FIELD SERVICE BULLETIN

FSB Number: LVCCFSB2005-36
Author: Tom Johnson
Date: February 25, 2005
Total No. of Pages: 3
Subject: **CDMA V810, E310, V510 Serial Communication**
Models Affected: CDMA V810, E310, V510
Level of Repair: 3, 4

Figure 1. E310 PCB. IC303 is highlighted.

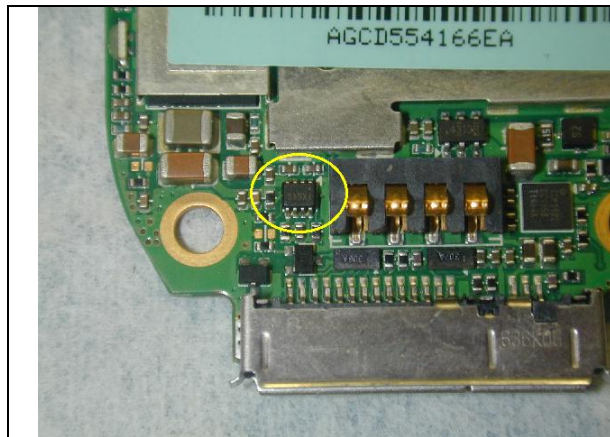
1. With the phone powered off and a charged battery installed:
 - a. Measure the DC voltage on Pin 7 of the CE Connector.
 - b. A correct part will indicate 0 DC Volts on Pin 7 of the CE Connector.
 - c. An incorrect part will indicate the battery voltage on Pin 7 of the CE Connector.
 - d. If battery voltage is present on Pin 7 of the CE Connector, Replace IC303 with the correct part number 51-46101-01.
 - e. Figures 1 and 2 indicate the IC303 placement on the respective models.
 - f. Figure 3 shows the correct part marking HXxxx.
 - g. Figure 4 shows the wrong part marking FKxxx.
